**Planning Department
Transportation Development Services**

Re: Starbucks and Burger King, 1000 Rio Grande Blvd. NW
Traffic Circulation Layout/ NO TIS Required
Engineer's Stamp dated 02-27-15 (H13-D021)

1000 RIO GRANDE BLVD., NW
SITE PLAN FOR BUILDING PERMIT

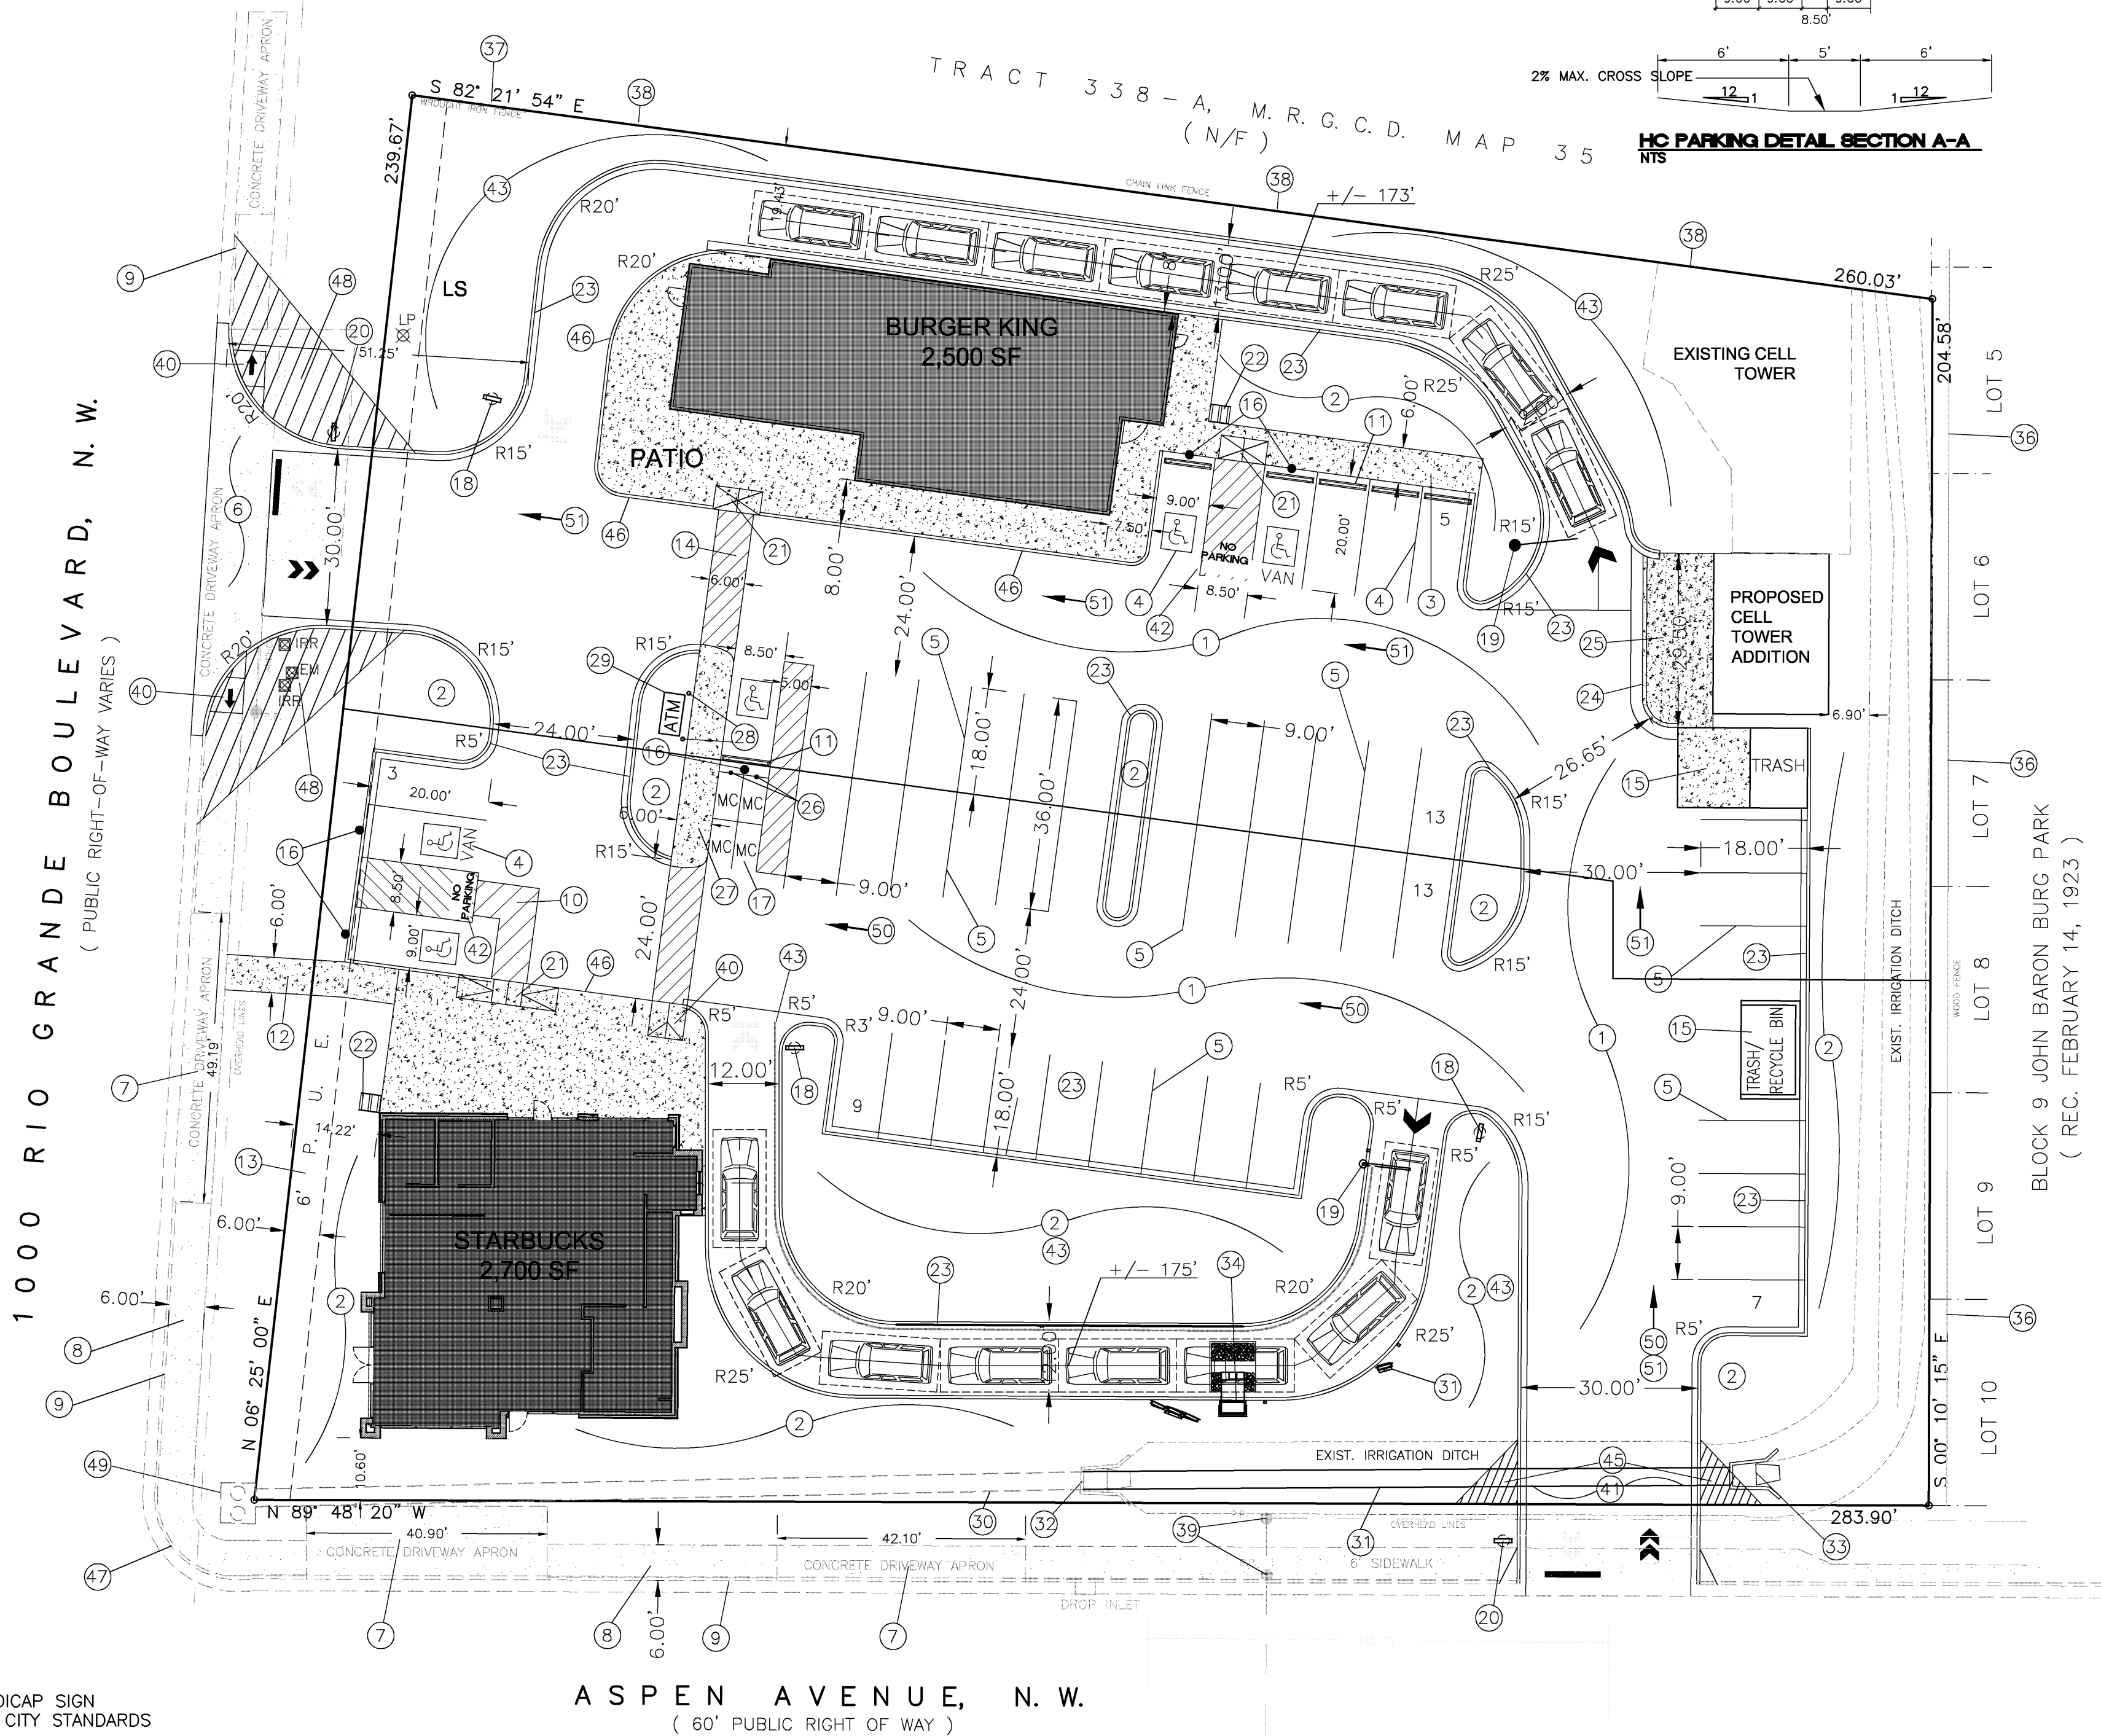
The TCL submittal received 02-27-15 is approved for Building Permit. A copy of the stamped and signed plan will be needed for each of the building permit plans. Please keep the original to be used for certification of the site for final C.O. for Transportation.

A TIS will not be required for this site. Your trip generation data was reviewed to show that the trip generations do not meet the threshold for a TIS. The City also compared the data against Starbucks trip generation data and took into account that the subject site is an existing gas station site. In addition, although AM Peak hour tends to generate a lot of traffic for this type of development, Rio Grande Boulevard itself does not tend to carry as much AM Peak traffic as other major roads due to the types of development around this corridor.

When the site construction is completed and a Certificate of Occupancy (C.O.) is requested, use the original City stamped approved TCL for certification. Redline any minor changes and adjustments that were made in the field. A NM registered architect or engineer must stamp, sign, and date the certification TCL along with indicating that the development was built in "substantial compliance" with the TCL. Submit this certification TCL with a completed Drainage and Transportation Information Sheet to front counter personnel for log in and evaluation by Transportation.
